Form 3160-5
(June 2019)UNITED STATES
DEPARTMENT OF THE INTERIOR
BUREAU OF LAND MANAGEMENTFORM APPROVED OMB
No. 1004-0137 Expires:
December 31, 2024**SUNDRY NOTICES AND REPORTS ON WELLS**
**Do not use this form for proposals to drill or to re-enter an
abandoned well. Use Form 3160-3 (APD) for such proposals.**

8. Well Name and No. Caprock Queen

9. API Well No. 30-005-00978

**Drickey Queen Sand Unit 805
30-005-00978
Trigg Oil Co.
January 24, 2025
Conditions of Approval**

Well Bore Diagram Worksheet

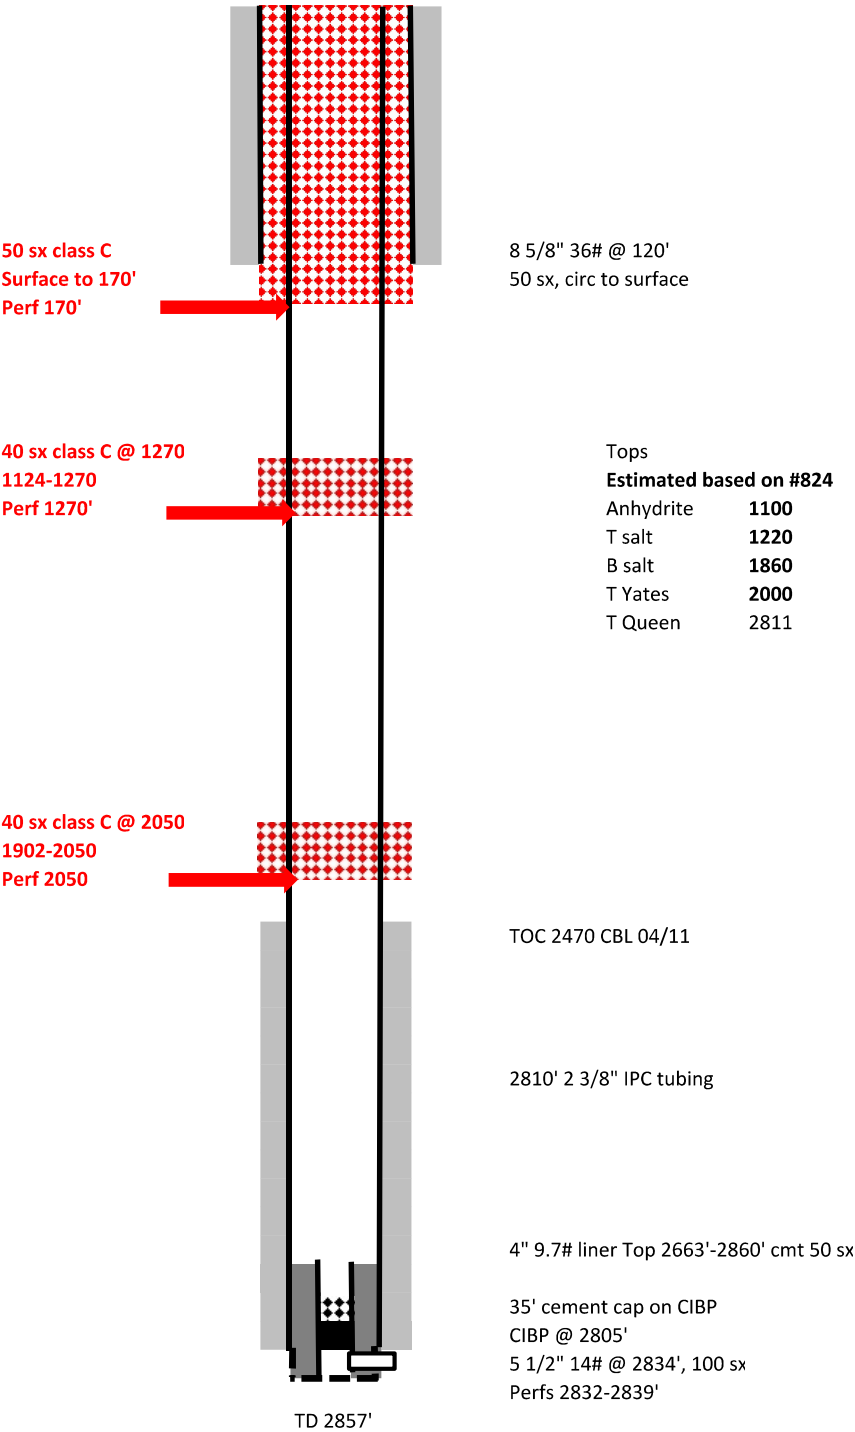
- 1. Operator shall TAG CIBP. Operator shall place an additional 25sx cement. WOC and TAG. Tag must be a minimum of 2,613' to cover the top of liner.**
- 2. Operator shall perf at 2,113' and squeeze cement class C cement to 1,709' to seal the Yates and bottom of the Salt. WOC and TAG.**
- 3. Operator shall perf at 1,359' and squeeze cement class C cement to 1,050' to seal the top of the Salt and the Rustler. WOC and TAG.**
- 4. Operator shall perf at 170' and squeeze cement class C cement to surface to seal the 13-3/8" casing shoe.**
- 5. Dry hole marker must be below ground.**
- 6. Surface reclamation will need to be completed once the well bore has been plugged. Please contact rflores@blm.gov for additional information.**
- 7. See Attached for general plugging stipulations.**
